Project Information	Contact Information
Padhye Residence 12642 NE 80th St, Kirkland, WA 98033	Bluefoot Architecture & Design - Jay Volz 206-355-1263 / jay@bluefootdesign.com

PROJECT	_____
PADHYE RESIDENCE	_____
ADDRESS	_____
12642 NE 80TH ST	_____
KIRKLAND, WA	_____
98033	_____
DRAWN BY	AD
CHECKED	JV
SCALE	_____
ISSUE DATES	_____
08/16/2023	_____
PERMIT SET	_____
REVISIONS	_____
1/16/24 REVISION	
DRAWING INDEX	_____
BUILDING SECTIONS /	_____
CONSTRUCTION	_____
ASSEMBLY SCHEDULE	_____
CERTIFICATION	_____
SHEET NO	A4.1

PADHYE KIRKLAND RESIDENCE AND DADU

SITE PLAN

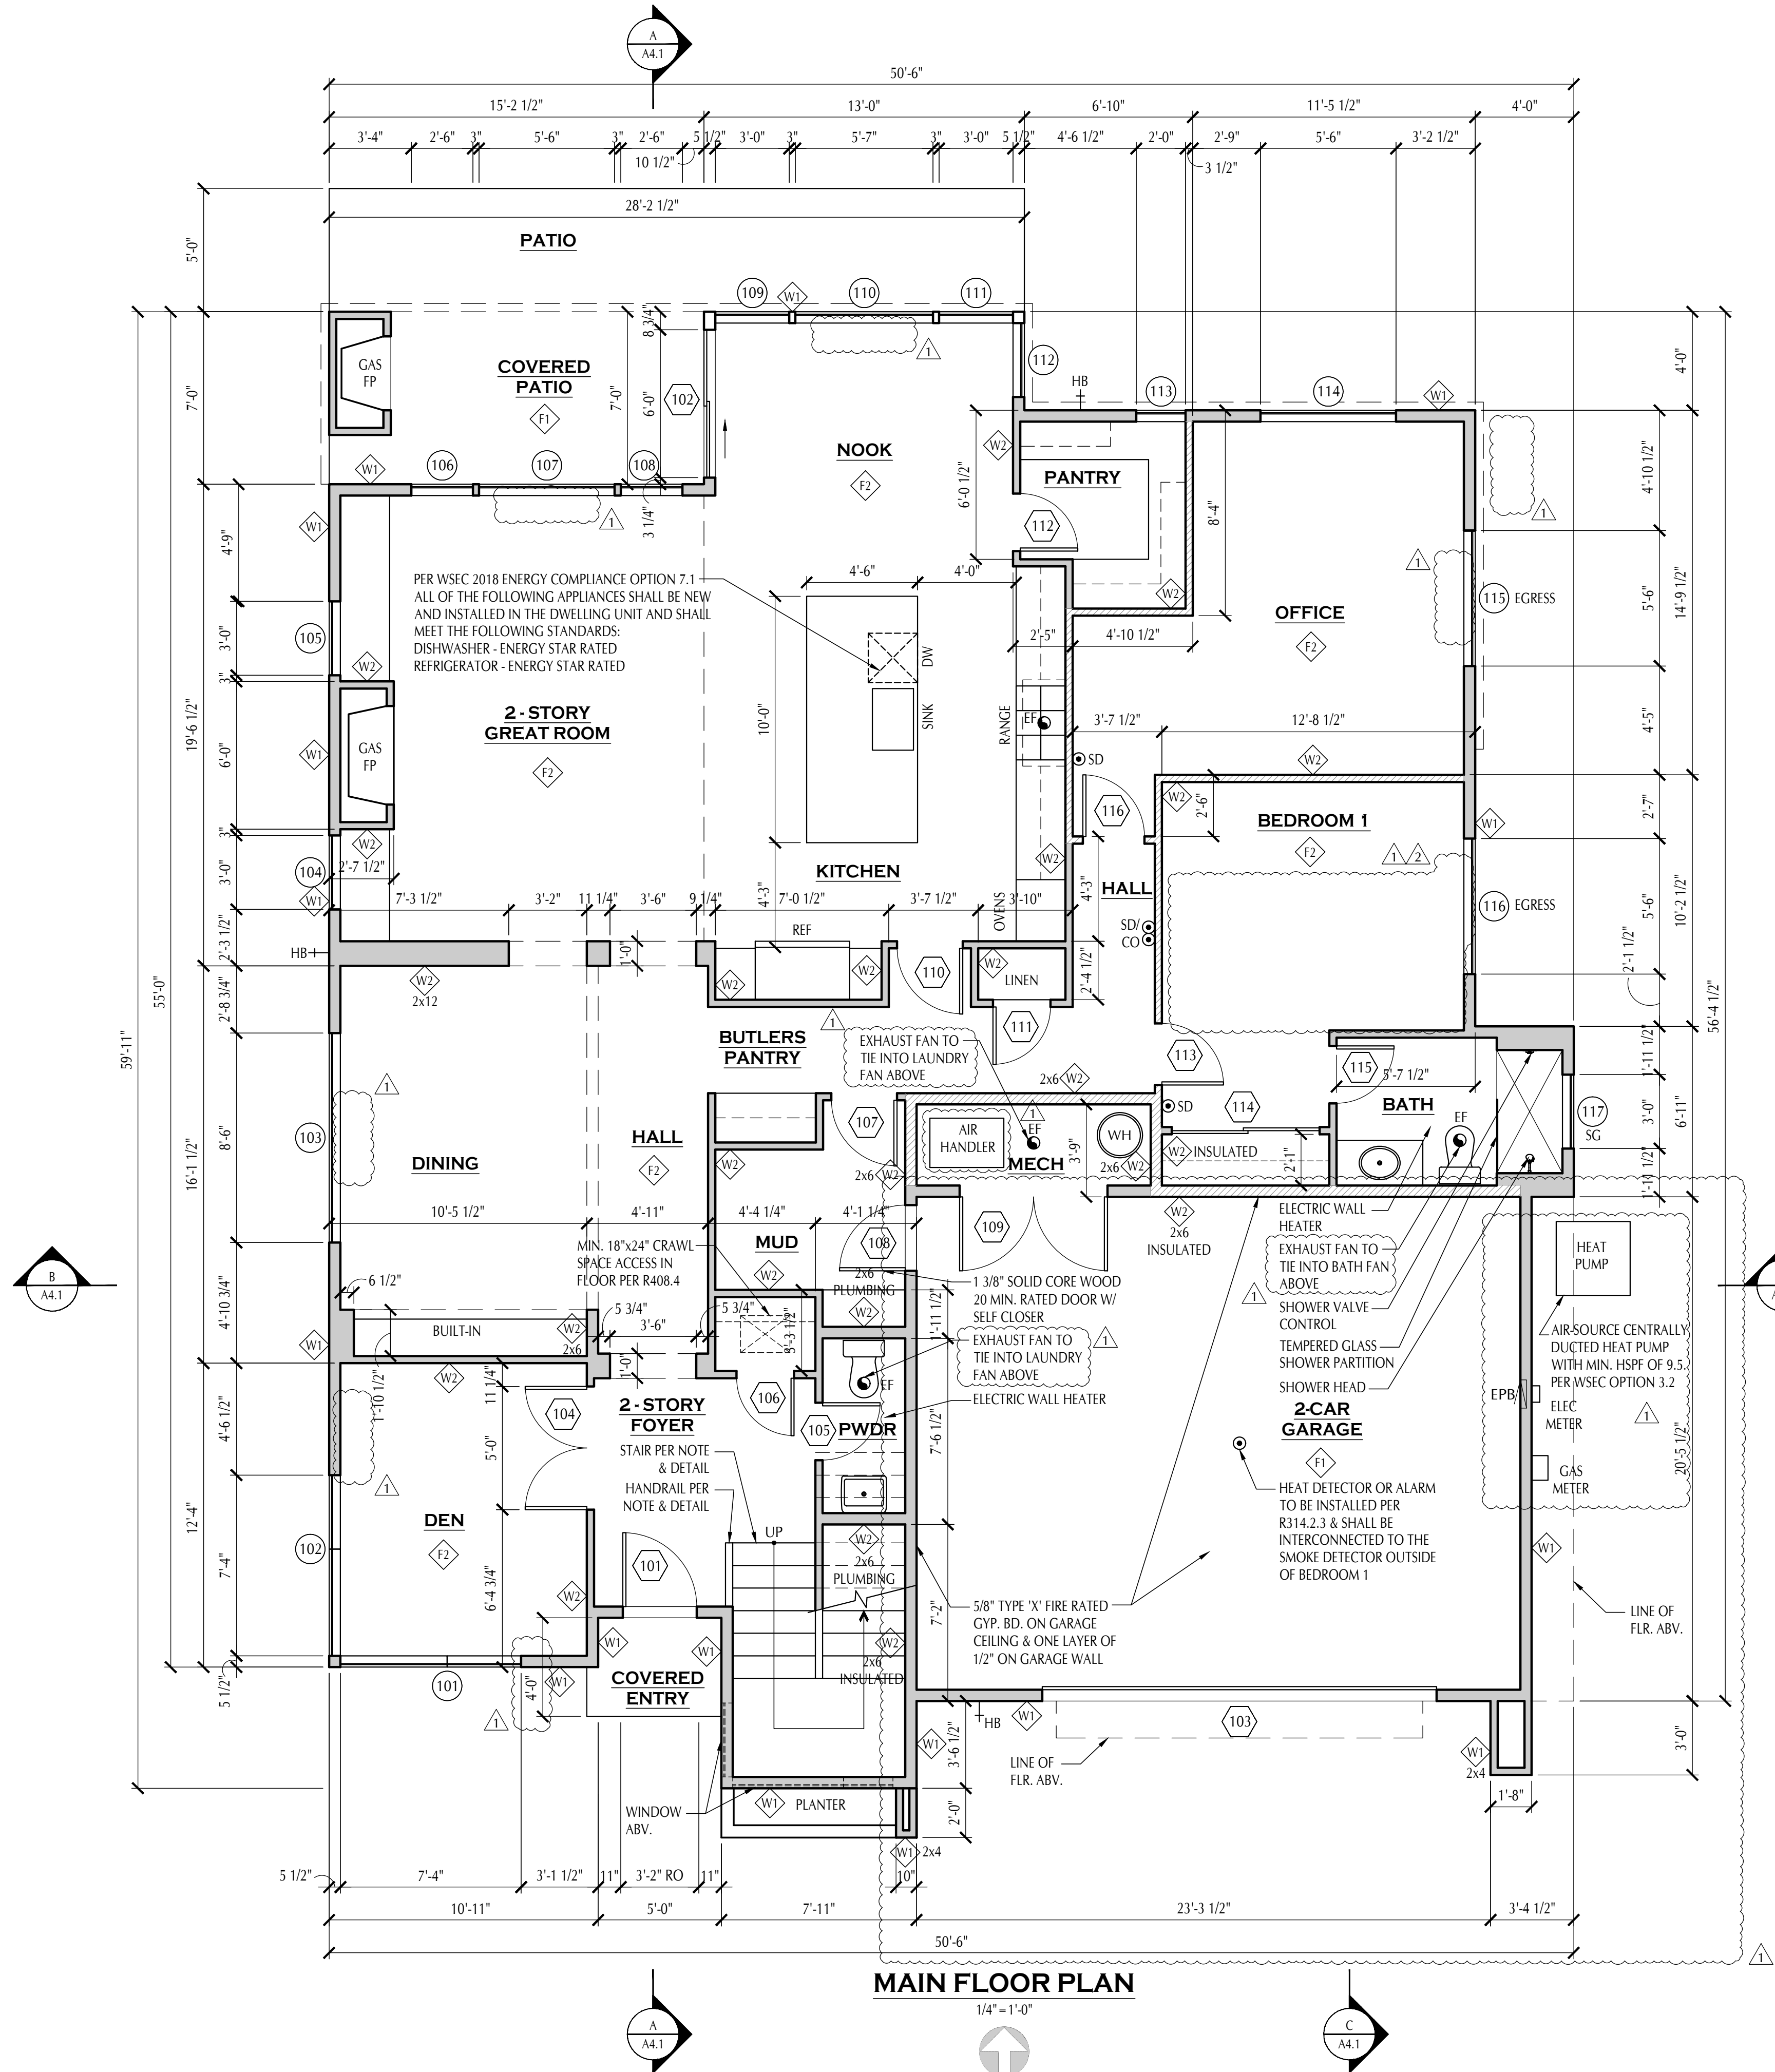
Add street trees 30 ft on center

GRADING AND DRAINAGE DETAILS

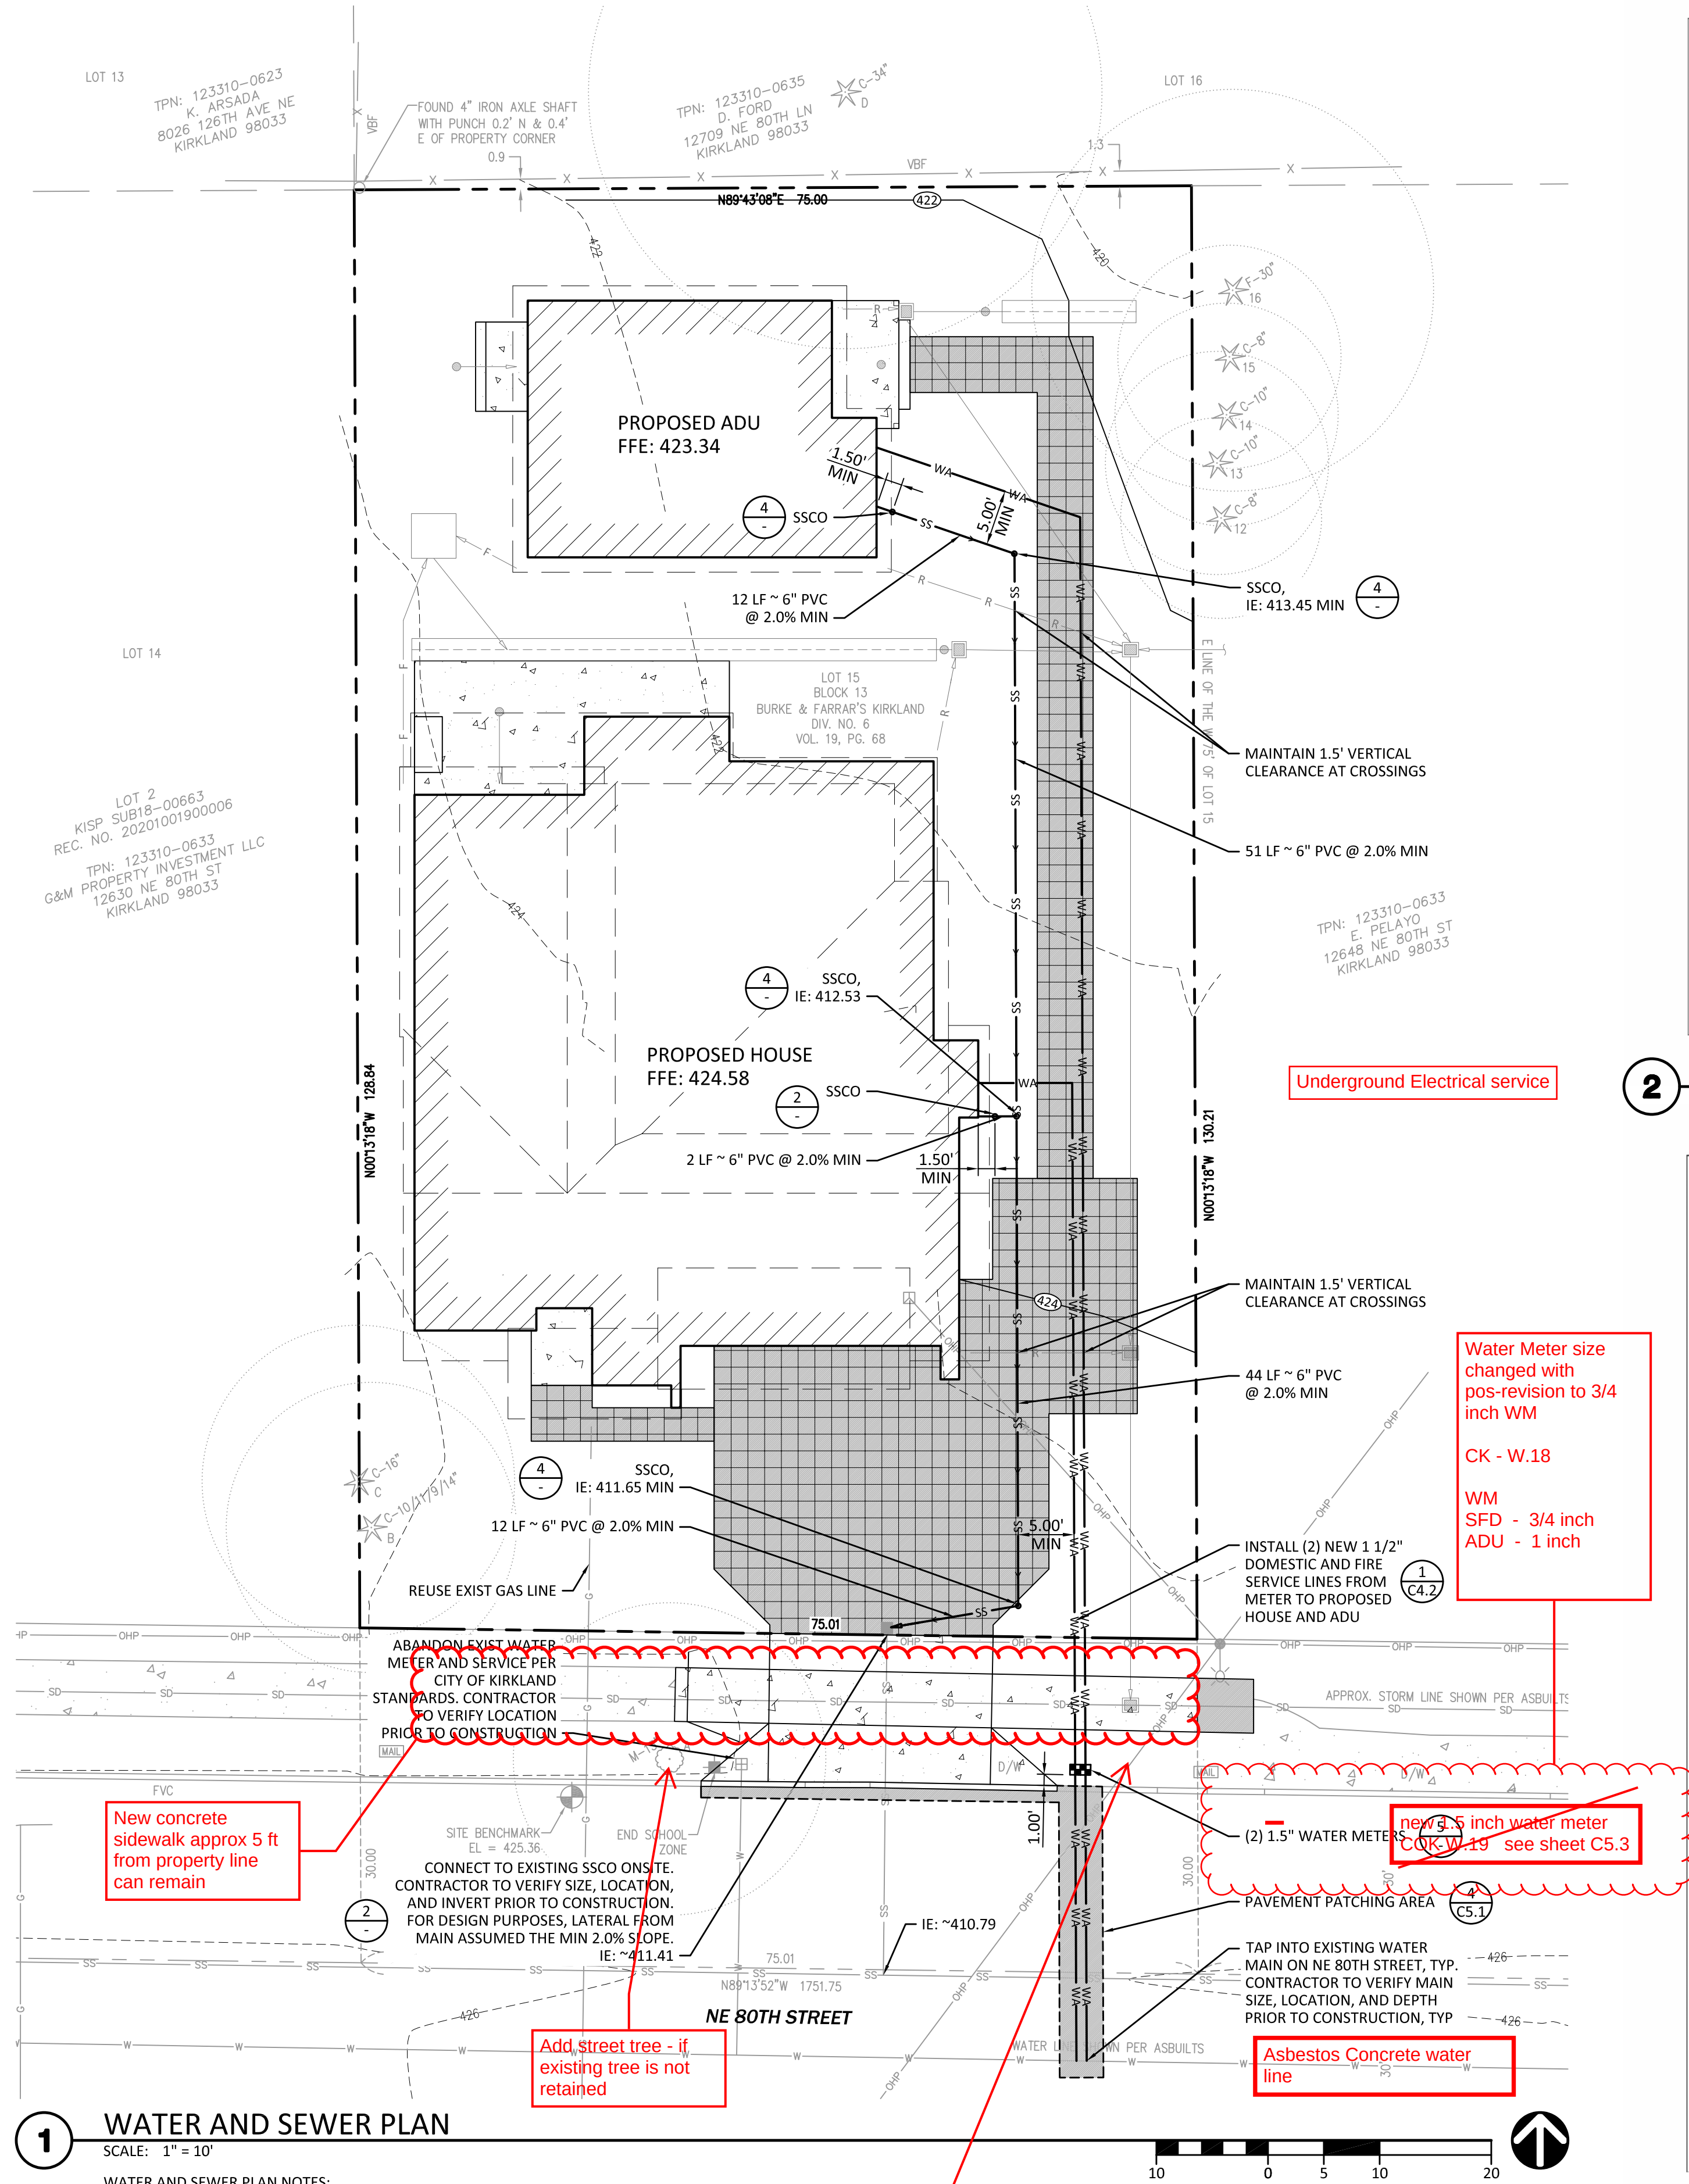
Add street tree.
Required at 30 ft on
center.

Provide video to PW inspector
